Title: **STAGE 1 ROAD SAFETY AUDIT**  
**For;**  
**St. Vincent's Hospital Redevelopment,**

Client: **OCSC Consulting Engineers.**

Report reference: **1787R01**

VERSION: **FINAL (29-3-2023)**

Drawing R517-OCSC-XX-XX-DR-C-0115 S4 P03.

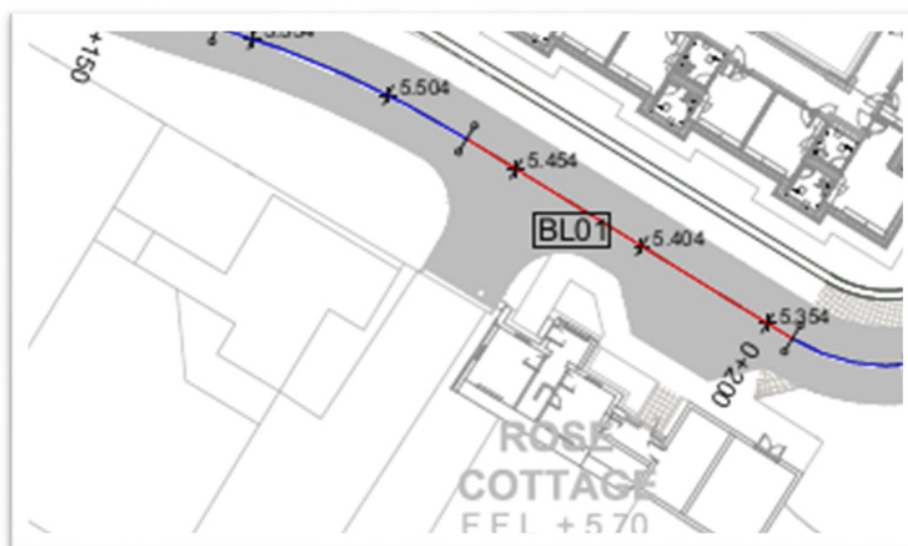
Richmond Road is subject to improvements for pedestrians and cyclists as part of other planned schemes. It is important that the proposed accesses on Richmond Road will be compatible with such schemes to ensure continuity of facilities for vulnerable road users in the future.

It is recommended that consultation with Dublin City Council be undertaken with regard to planned improvements along Richmond Road to ensure compatibility.

3.2	No	No	DCC have been consulted in this regard and have advised that there are no details currently available regarding the planned upgrades to Richmond Road. It should also be noted that the development frontage on Richmond Road is relatively limited and is considered compatible with any future upgrades, based on discussions with DCC.	Yes

Drawing R517-OCSC-XX-XX-DR-C-0110 S4 P03, Convent Avenue.

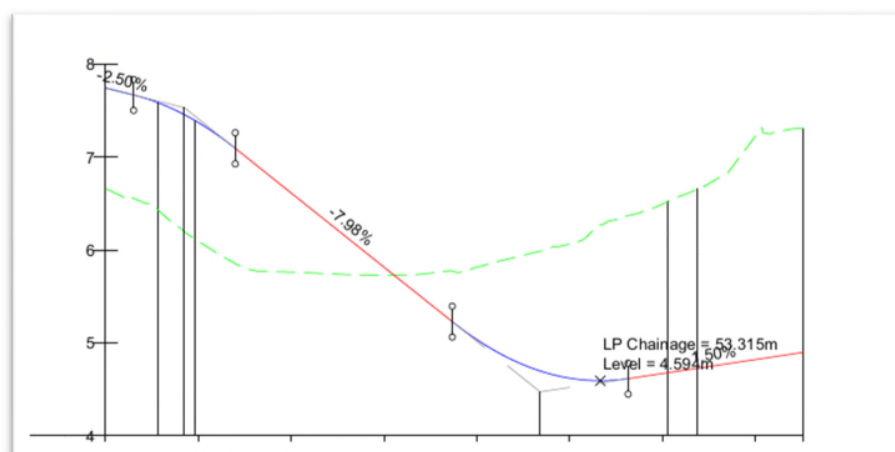
It is proposed to provide a link for vehicular traffic to Convent Avenue. Convent Avenue is a narrow lane and there is just enough room for vehicles to pass if no illegal parking is taking place. The introduction of additional traffic could lead to long reversing manoeuvres resulting in material damage of vehicles or collisions with vulnerable road users.

Restrict access to Convent Avenue.

3.3	No	No	As per the Servicing and Delivery Access Management Plan, the hospital will be serviced from the entrance on Richmond Road. Convent Avenue is expected to be maintained as an access for exceptional use only. All day-to-day access will be via the access junction on Richmond Road.	Yes

Drawing R517-OCSC-XX-XX-DR-C-0131 S4 P03. Road BL06

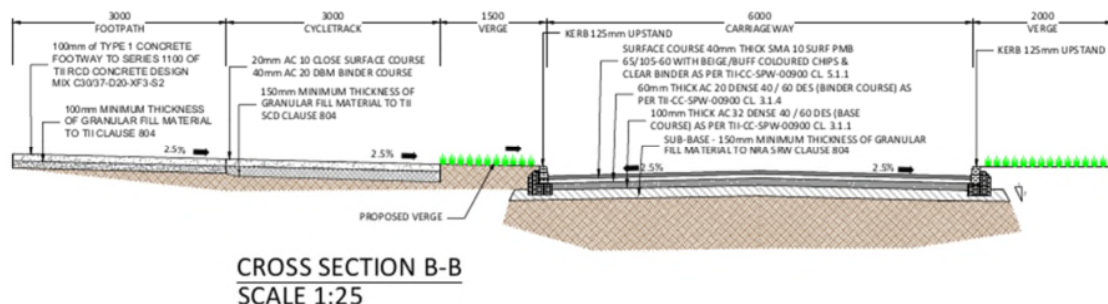
The vertical alignment of Road BL06 has a maximum gradient of 7.98%. This could lead to inaccessibility or falls for pedestrians travelling along the road or on the adjacent footpath if it has matching gradients,

It is recommended that footpaths and routes for pedestrians be kept to 5% as far as practicable throughout the development.

3.4	No	No	Road BL06 will be used for service and delivery operations at the hospital exclusively. There isn't any pedestrian or cyclist access	Yes

associated with this road, which means that the observed standards aren't applicable.	
3.5	Yes	Yes	Cross section B-B has been updated to reflect the road layout. This shows a 3m wide shared surface adjacent the road surface, rather than segregated facilities.	Yes
3.6	Yes	Yes	This has been updated to allow for a continuation of the shared facility to connect appropriately with the road.	Yes
3.7	Yes	Yes	This has been updated to allow cyclists to access the road prior to the roundabout, where they will share the road surface with vehicular traffic. The shared facility will then convert to a pedestrian walkway where it will cross the road at the western leg of the roundabout and tie into further pedestrian infrastructure within the site.	Yes

Drawing R517-OCSC-XX-XX-DR-C-0145 S4 P03, Cross Section B-B.

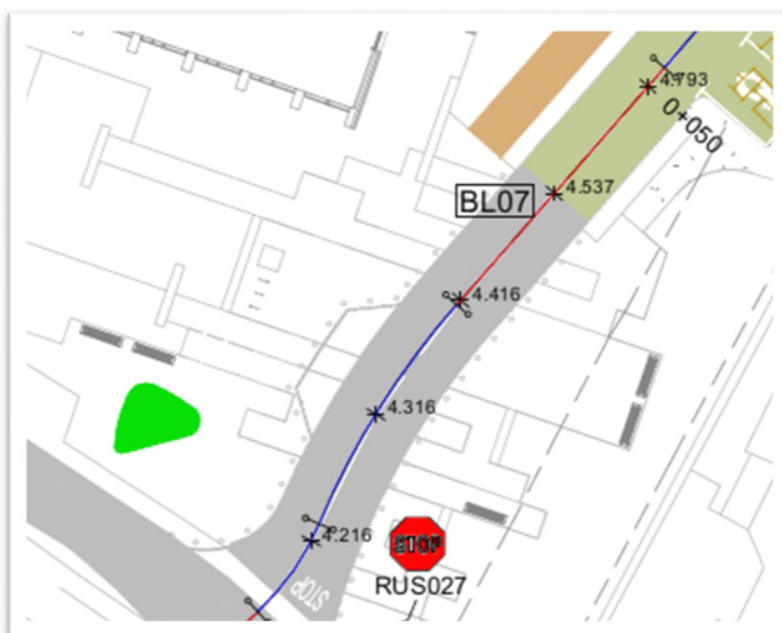
Cross Section B-B shows a segregated cycle track and footpath each of 3m width on Road BL07. It is unclear if this cross section is maintained in other roads with the cycle track or if the same rendering colour been used for shared use tracks. A lack of distinction between segregated and shared use tracks could lead to collisions between two user groups.

Ensure shared use facilities for pedestrians and cyclists are adequately wide to cater for both user groups and that the interface between shared use areas and segregated use areas for pedestrians and cyclists are clearly defined for visually impaired users.

Drawing R517-OCSC-XX-XX-DR-C-0110 S4 P03, BL07 Cycle facilities.

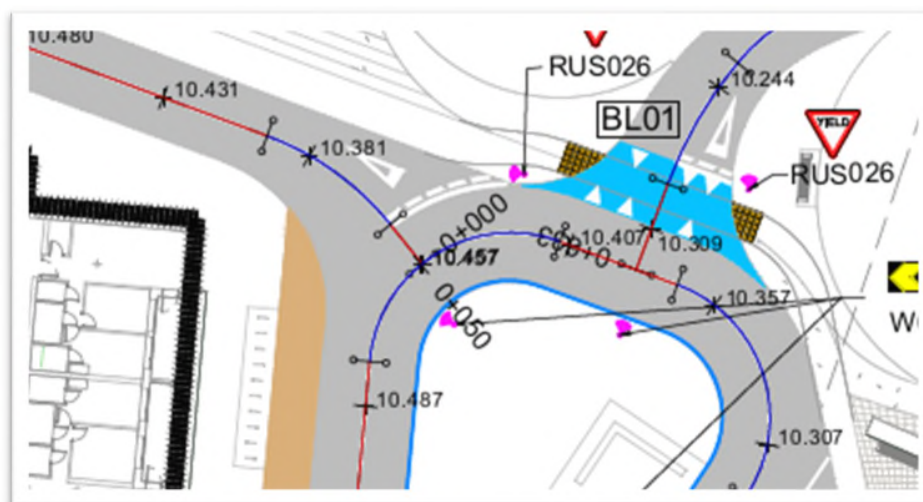
There is a discontinuity in cycle facilities between the 3m wide cycle track starting at Chainage 40 of BL07 and the start of BL07 at Richmond Road. It is also unclear if the cycle facility is a two-or one way facility and if it is two-way what crossing links are provided for access to the two-way facility along BL07.

Ensure continuity of facilities for cyclists along the entire route.
